Pre bid clarifications for Supply, Delivery, Installation, Commissioning and Maintenance
of Roof Top Solar System for ITI New Building. – SUP/SD/25/333

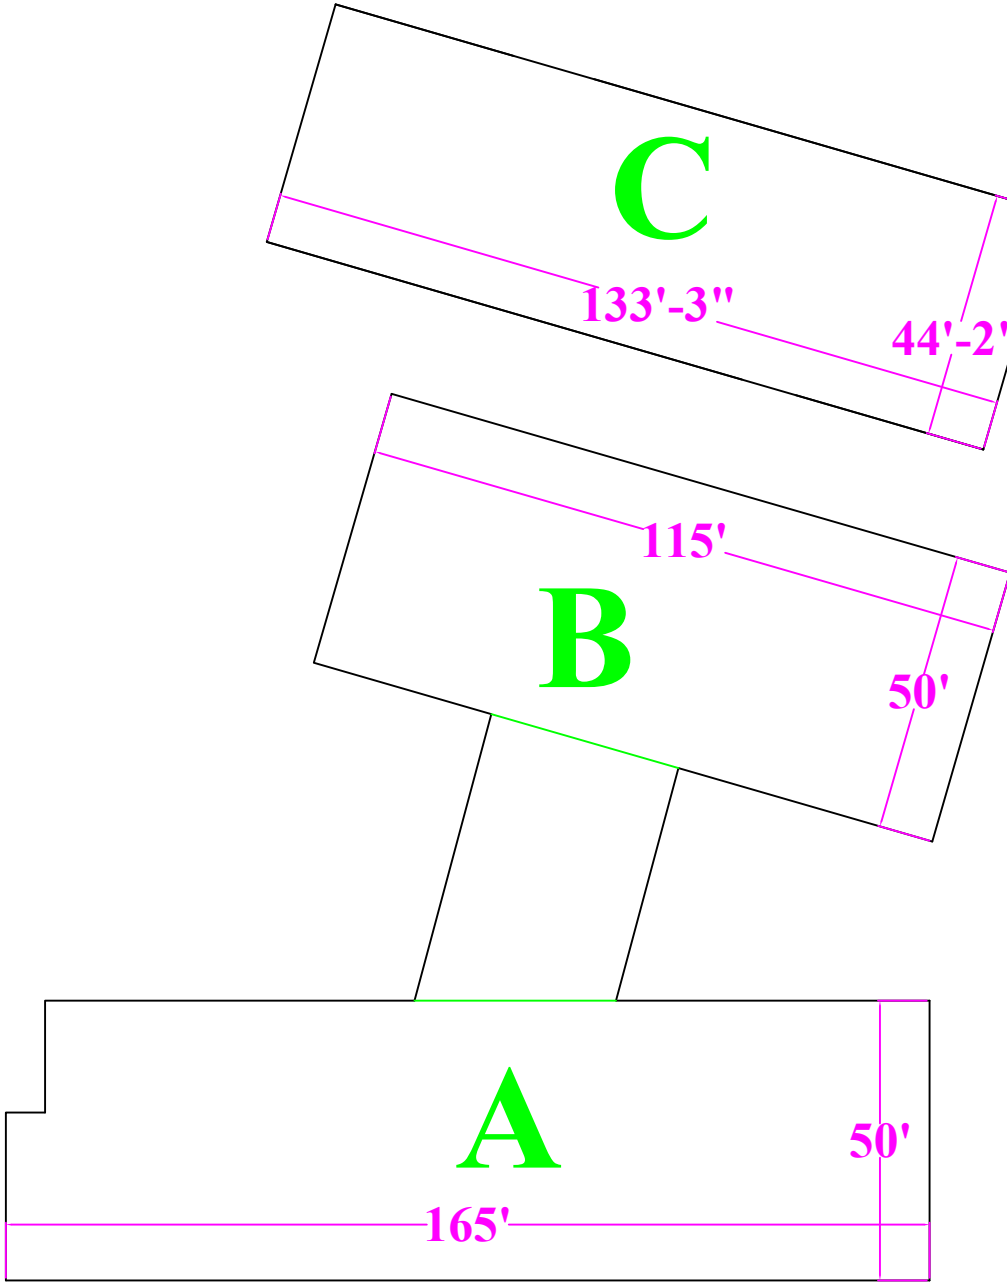
If a separate **Common Coupling Panel** is required, please confirm

Roof area C can be used if roof area A and B is not enough

Roof A ,B suggested area for solar pannel installation

CEB confirmed that a separate Common Coupling Panel is required behind the existing panel room
